**NOTICE OF DECISION**

**PROPOSAL:** A Type III Site Design Review (DR-17-22) for a 4,240 sf new building expansion to the Hybrid Heating & Air Conditioning site. The expansion includes a new warehouse, remodel of existing space for offices, a new parking lot area, landscaping and other minor site improvements.

**STAFF REPORT**

**Type III Site Design Review (DR-17-22)**

C2.0

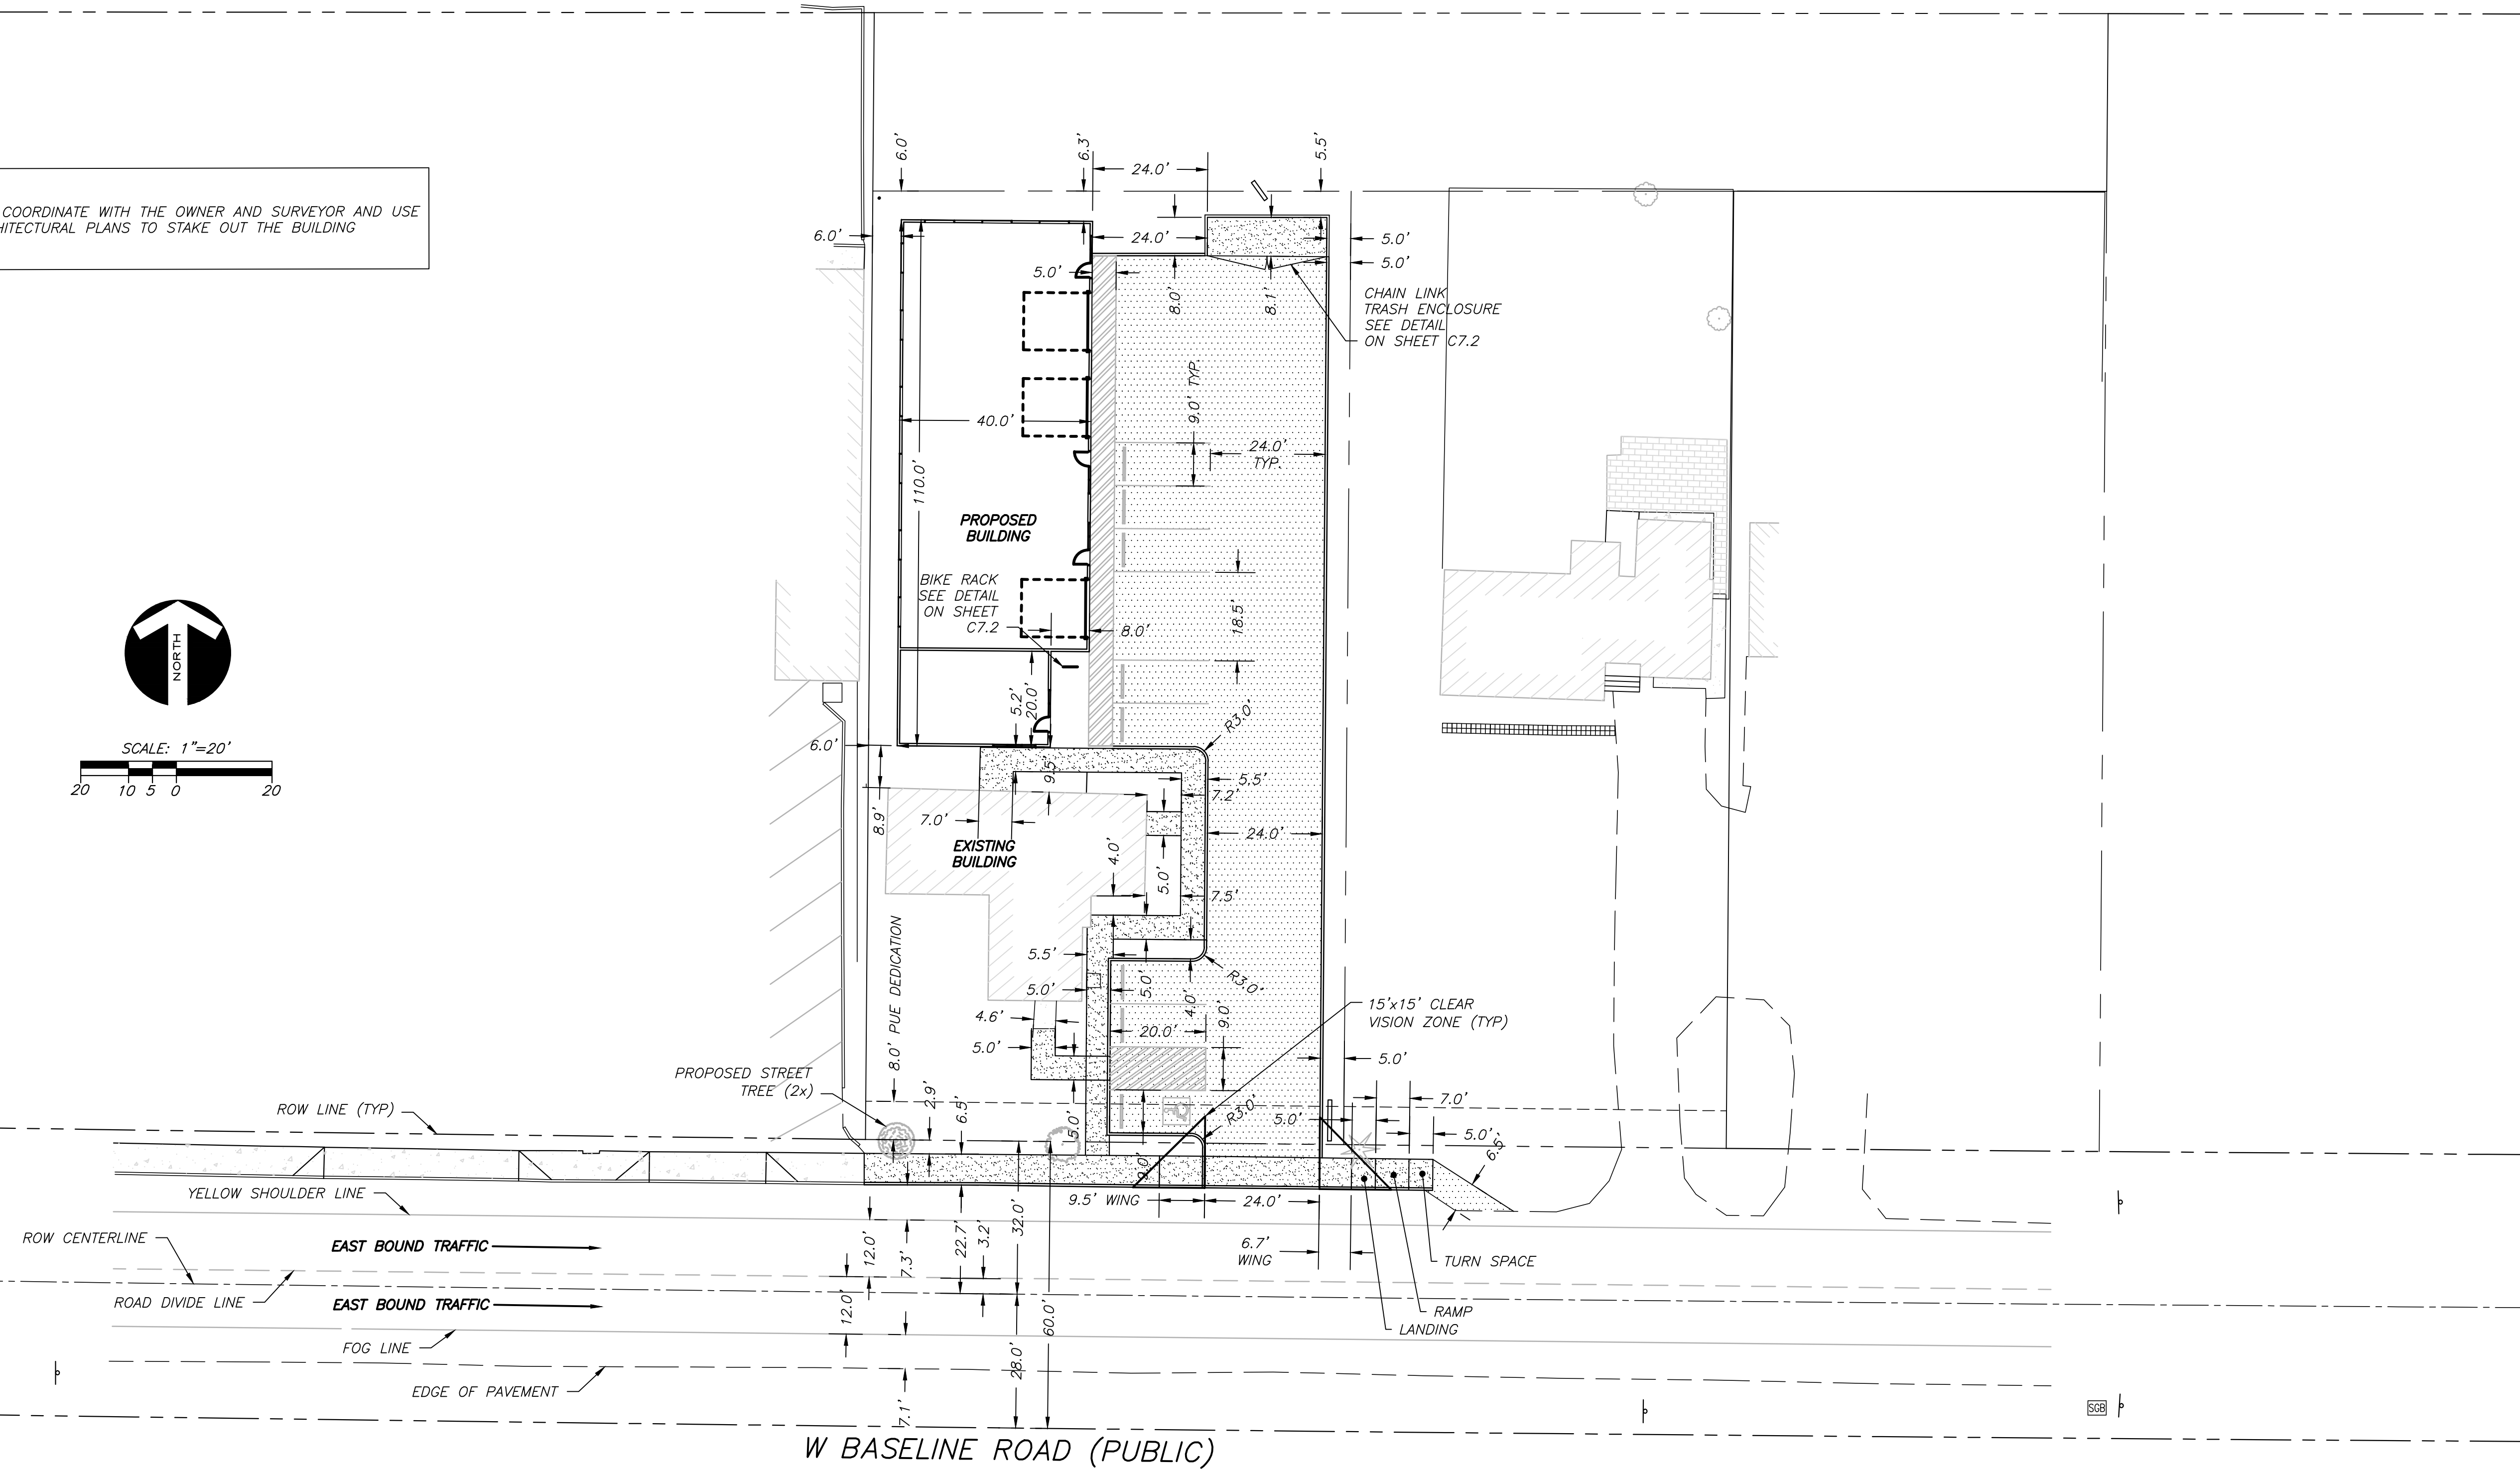
**Findings:** As shown within Exhibit "A", the applicant proposes to move the driveway access from the west to the east side of the Baseline frontage. As shown in Exhibits "A" and "B", both the City and ODOT (Response #12172) have found the driveway location acceptable. Clear vision areas are shown on Exhibit "A", Plan Sheet C2.0. A condition of approval shall require that the clear vision area adjacent to the driveway access as shown on Exhibit "A", Plan Sheet C2.0 remain clear.

The applicant is proposing a new walkway from Baseline Street to the front door of the existing office and new building as shown within Exhibit “A”, Plan Sheet C2.0. Staff finds that the new walkway will provide safe internal pedestrian connectivity.

The preliminary engineering plans (Sheet C2.0) show these street trees, however, the landscaping plan does not show the required street trees.

**COMPOSITE UTILITY PLAN**  
SCALE: 1" = 20'

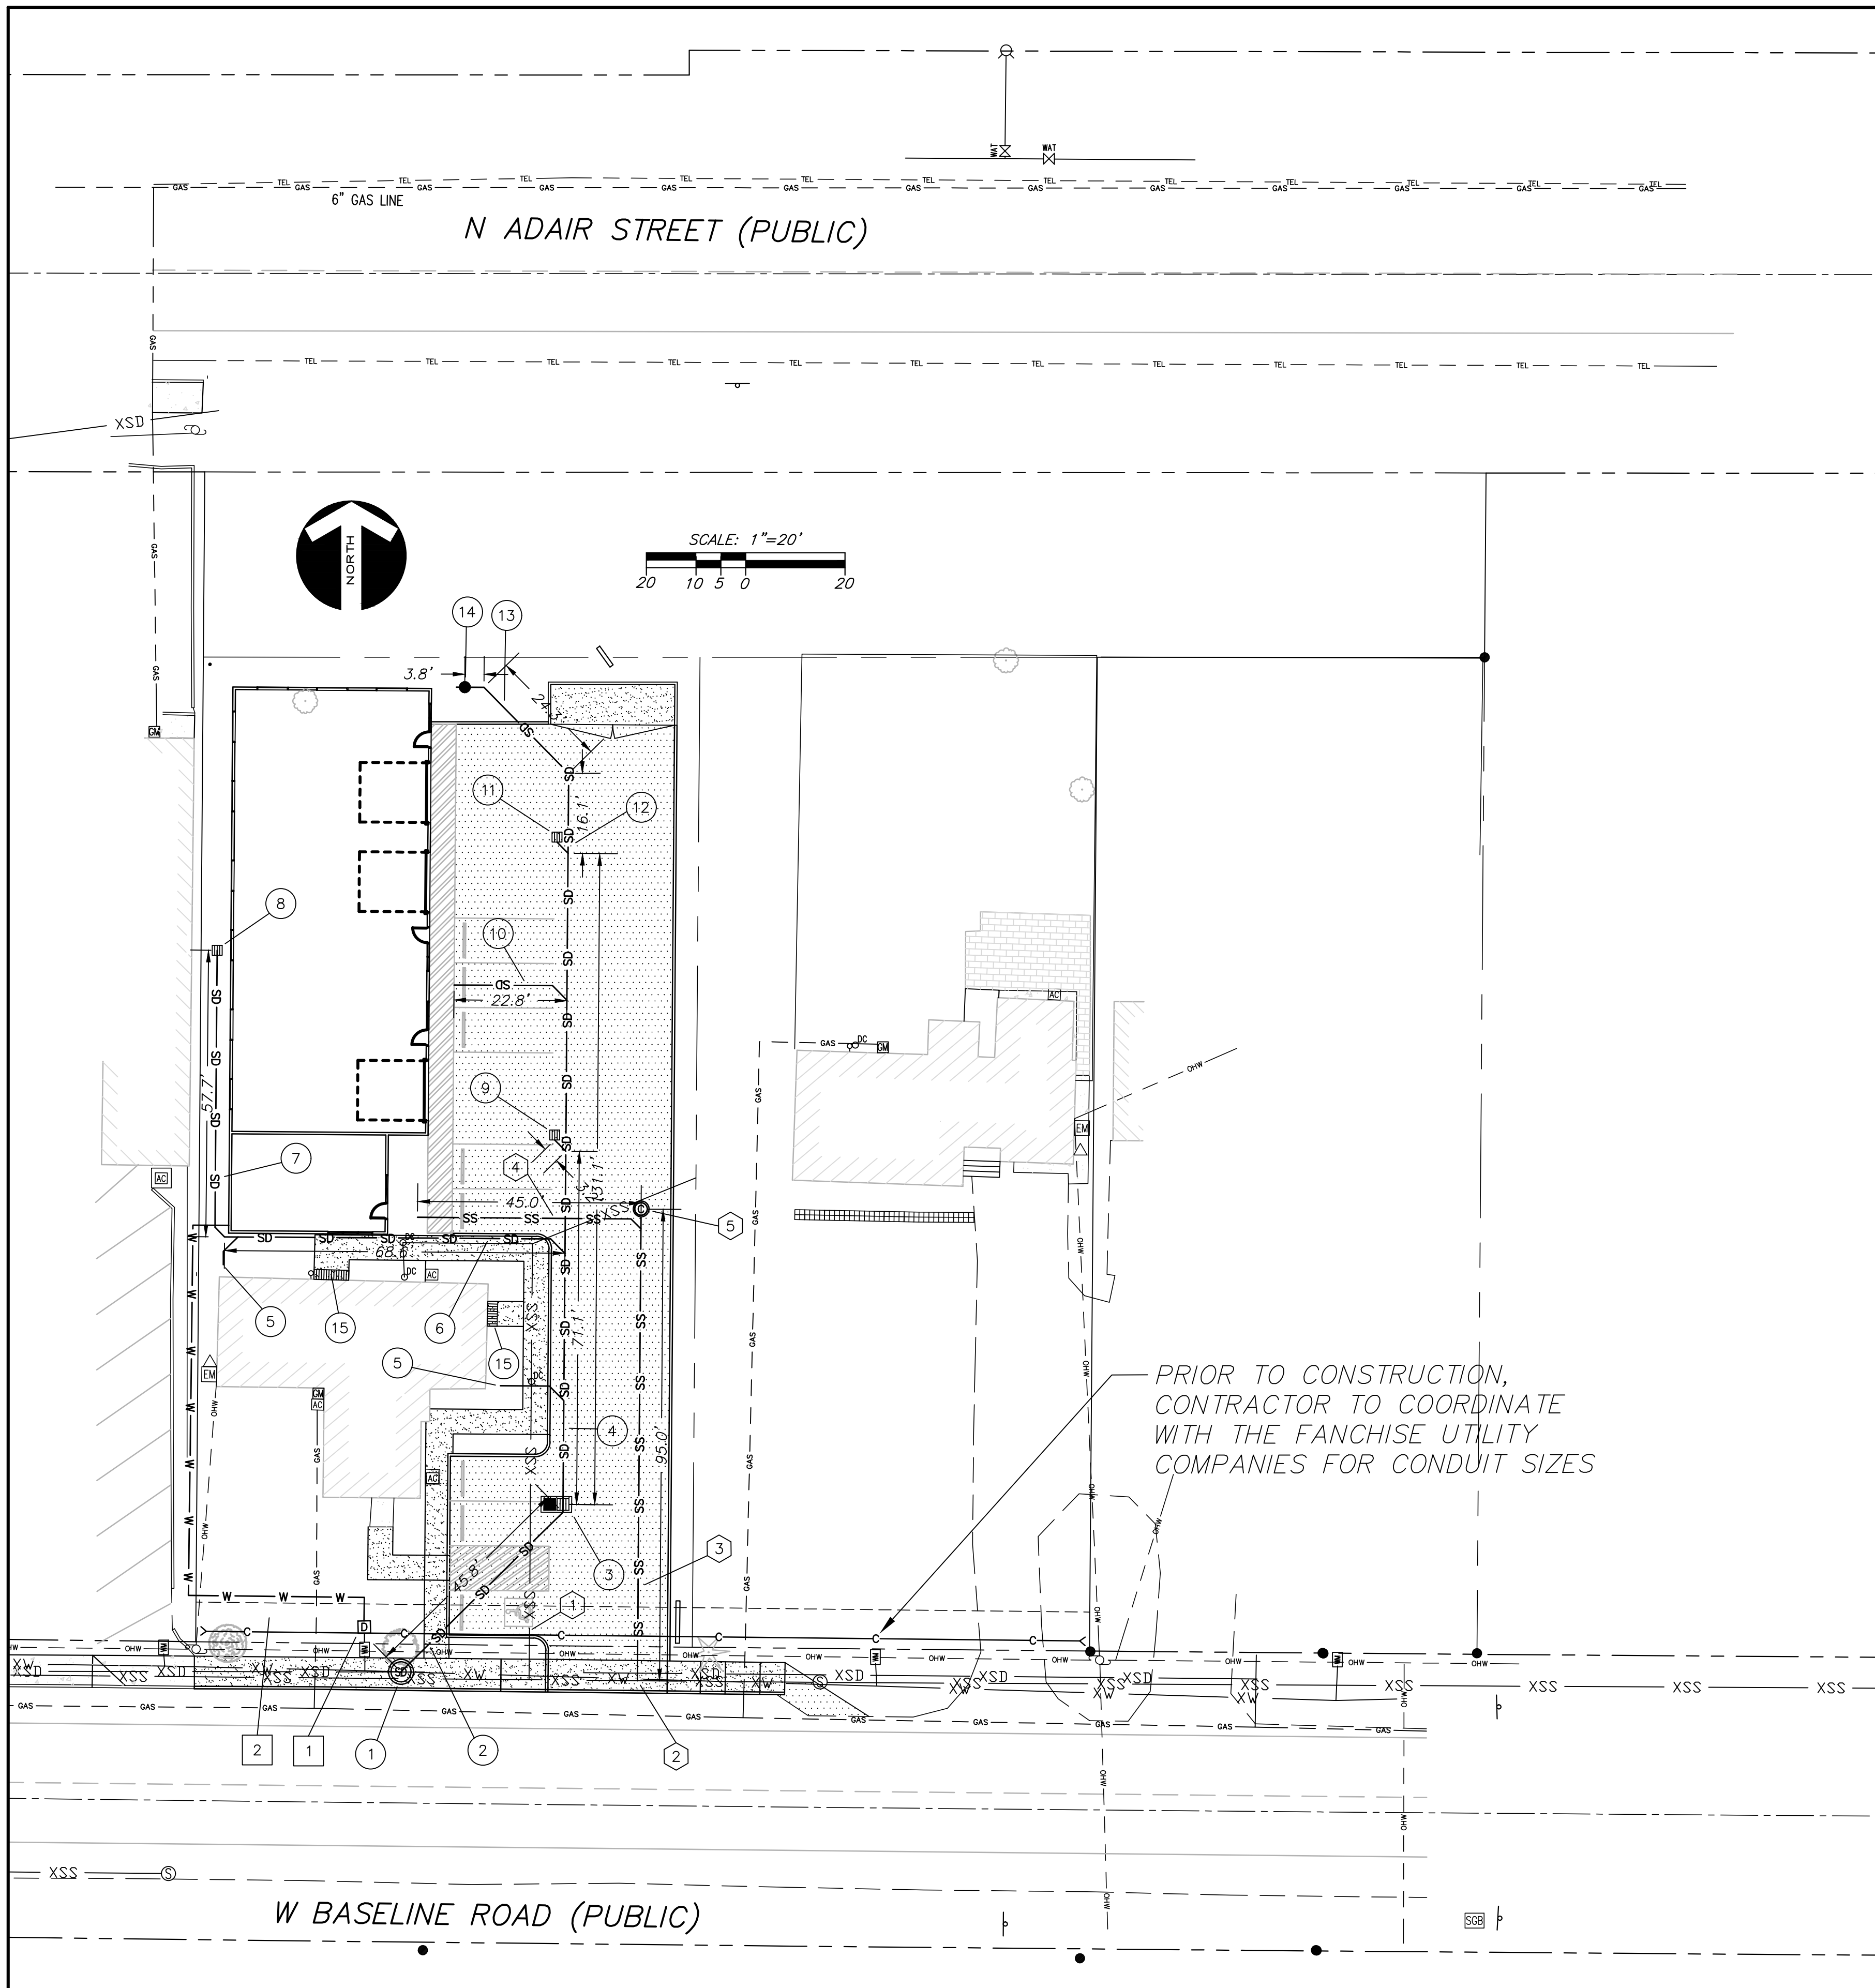
The applicant proposes to place a flat top manhole over the existing storm drain under the sidewalk along the frontage and then run a storm lateral into the site. This is acceptable to the City, however, the other utilities in this area may prevent installation of a flattop manhole. The applicant might entertain using a Type II Area Drain (CWS Detail 380) rather than a flattop manhole. Type II Area Drains are acceptable to the City in this situation and they allow easy City maintenance of the system.

**1**  
AS2  
**TRASH ENCLOSURE PLAN**  
SCALE: 3/4" = 1'-0"

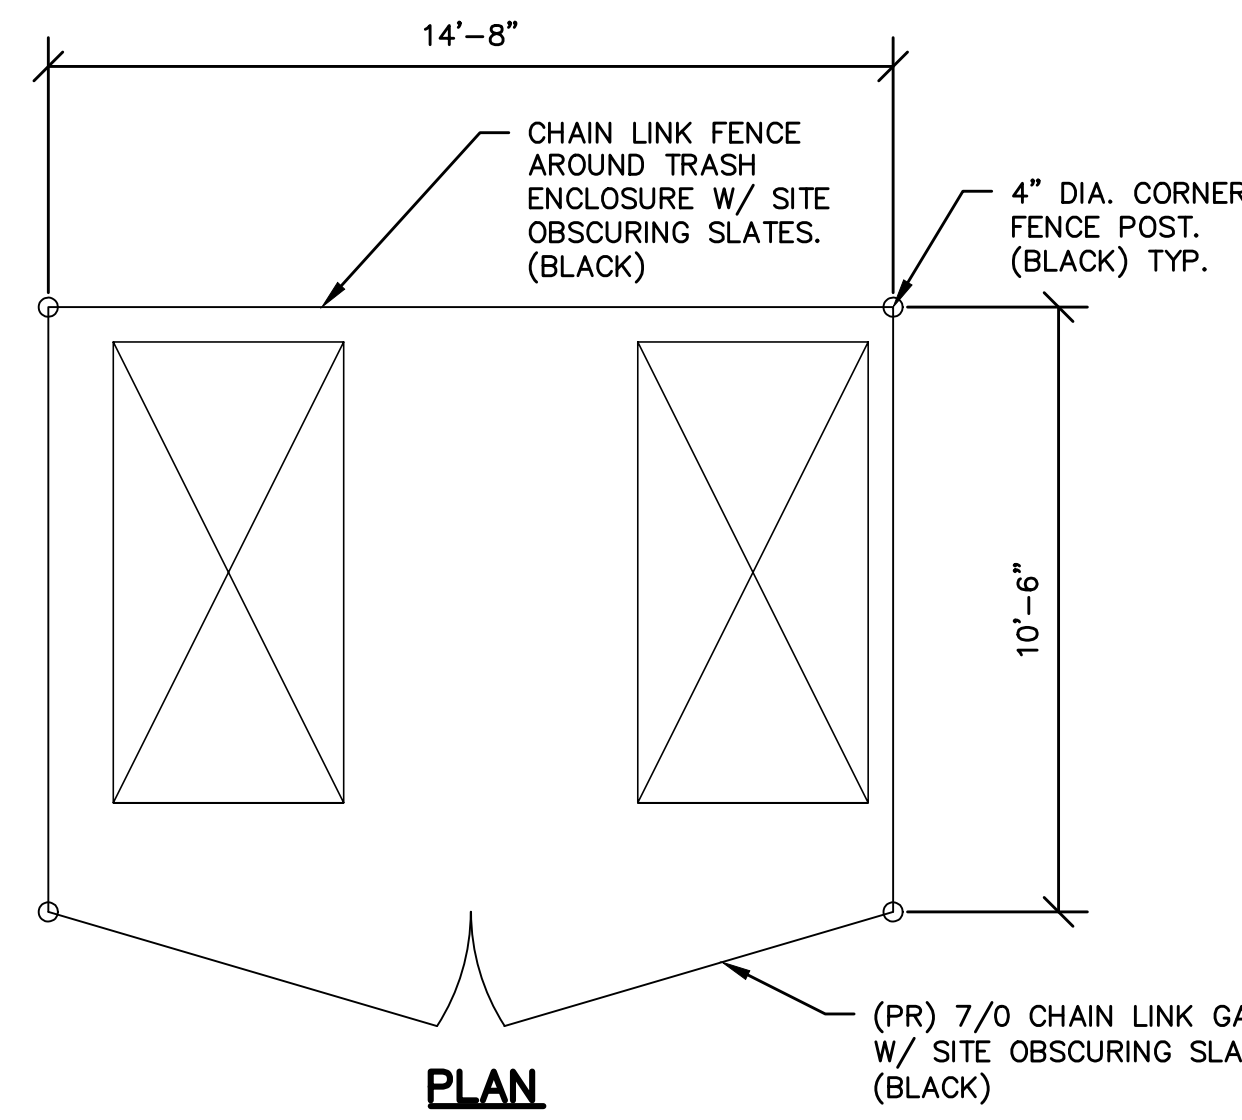
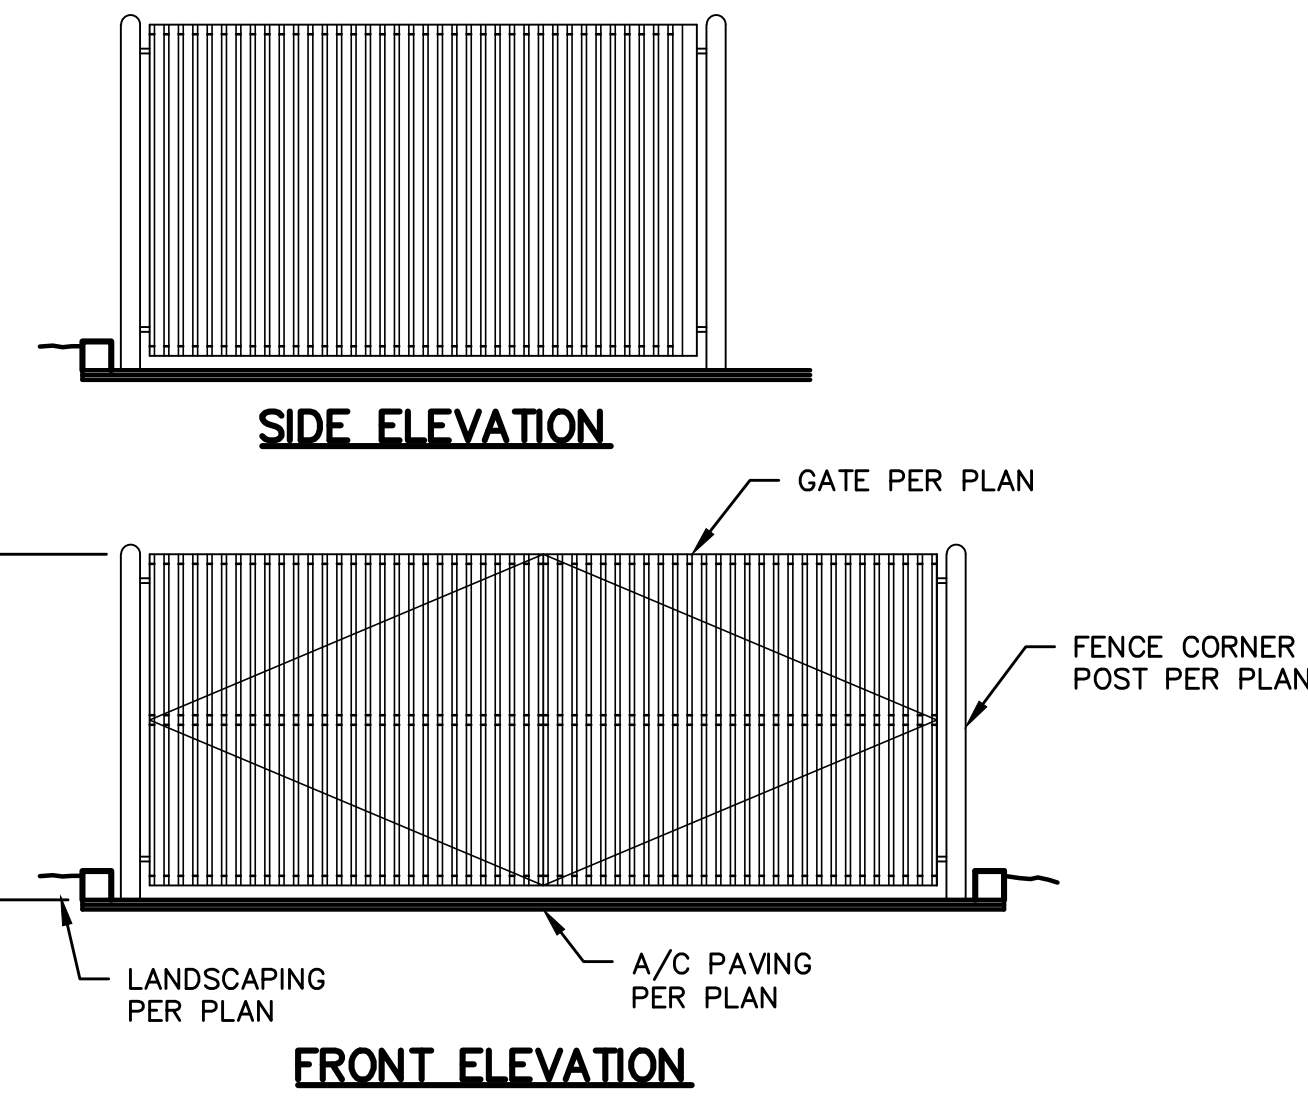
**Findings:** No outdoor storage is proposed with this application, other than an outside trash enclosure. The application plan sheet C7.2 notes the Trash Enclosure Plan. Staff finds that the appropriate screening will be provided as required by CMC 18.45.060(F) per Sheet C7.2.

**Findings:** The applicant proposes a screened garbage and trash collection area. The applicant provided a detail of this proposed facility and showed its location on the site plan and plan details within Exhibit “A”, Plan Sheet C7.2. The proposed screened garbage and trash collection area is not located within the front yard area, it is proposed at the rear of the property as shown on Exhibit “A”, Plan Sheet C2.0. A chain link fence with slats is proposed. The plans and details do not specify if the chain link fencing will be galvanized. As indicated above, galvanized chain link fencing is not permitted. Therefore, the proposed chain link fencing shall be a PVC or polymer covered. This shall be a condition of approval. Prior to issuance of final occupancy, the screened trash enclosure with slats shall be installed as shown within Exhibit “A”, Plan Sheets C7.2 and C2.0, with PVC or Polymer coating.

26. The screened trash enclosure with slats shall be installed as shown on Exhibit "A", Plan Sheets C2.0 and C2.7. Galvanized chain link fencing is prohibited, therefore; the fencing shall be PVC or polymer covered.
